53-55 Chalton Street, 60 & 70 Churchway
London
NW1 1JB, NW1 1LT

Basement Impact Assessment
Audit

For
London Borough of Camden

Project Number: 12985-71

4.2.3. Basement Excavation Criteria

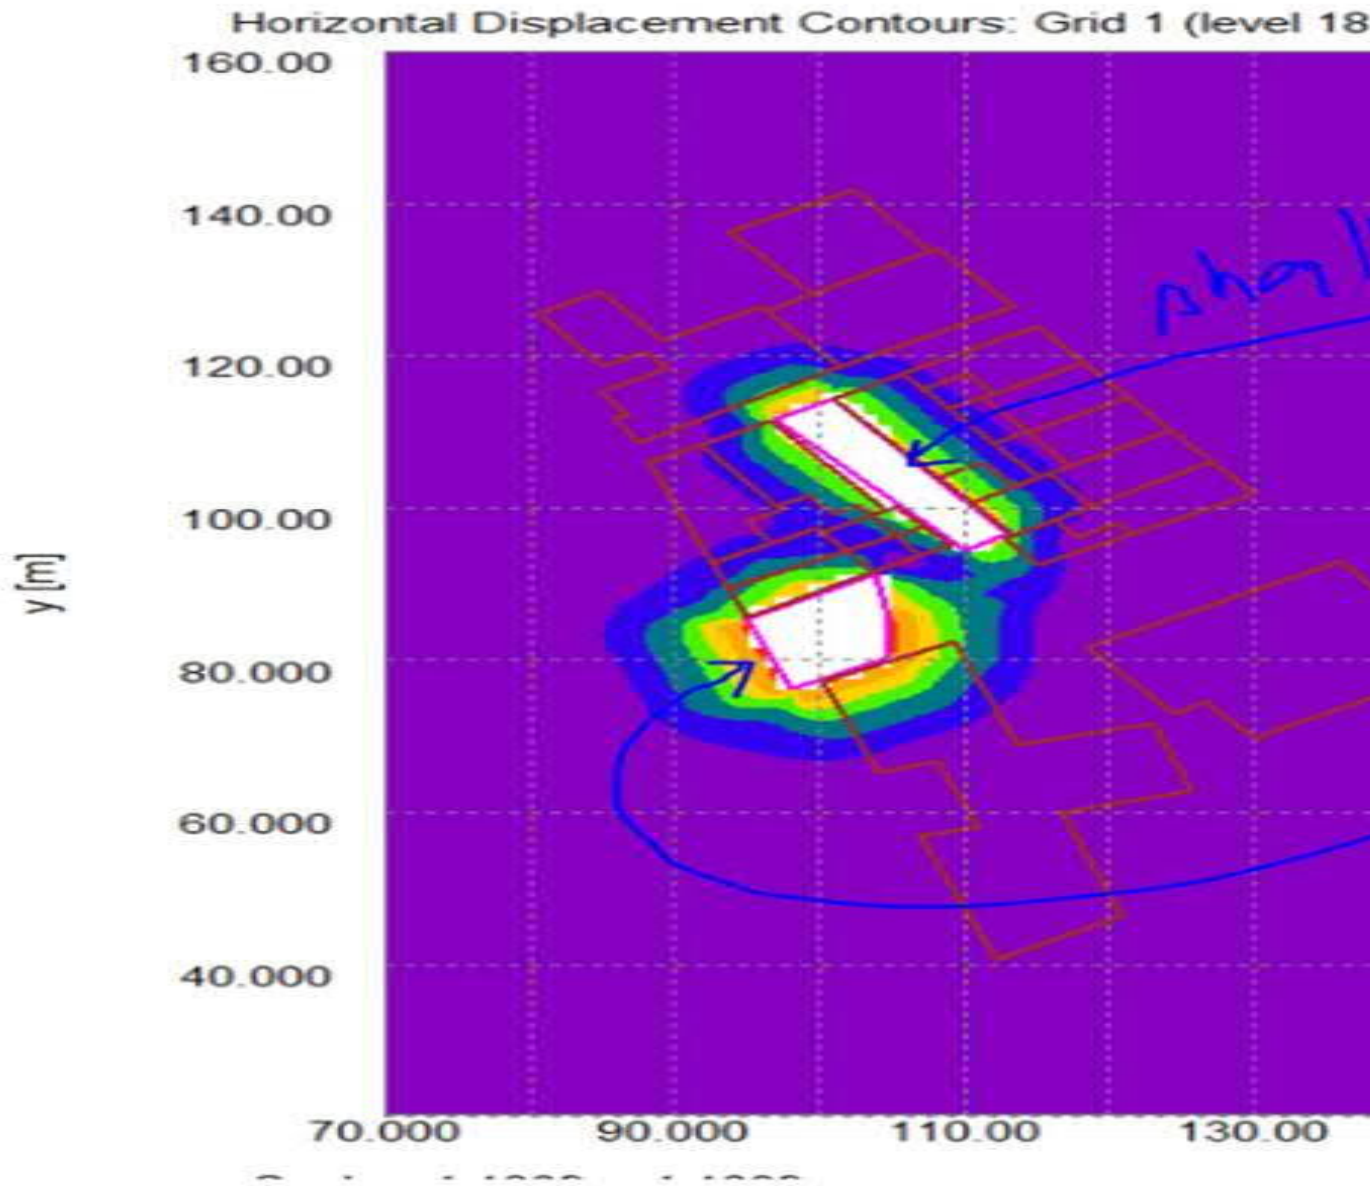
I clarify the basis of the cat 1 damage predictions in our GMA;

Underpinning installation horizontal movement has been considered as being 2mm

Bulk excavation horizontal movement has been considered as being 4mm

As part of the assessment presented herein, the empirical CIRIA 760 excavation was scaled to 80% which equates to a maximum movement at surface levels of 4mm during the excavation phase. The assessment assumes that the maximum horizontal movements due to the underpinning works in isolation are 2mm towards the site. Adhering to these limits would ensure the robustness of the solution and help to limit the possible damage of the neighbouring properties to Category 1 (Very slight).

The horizontal movement at ground level considered in the damage classification by XDISP is thus 2mm + 4mm + 6mm. The result of this can be seen in the plot below;
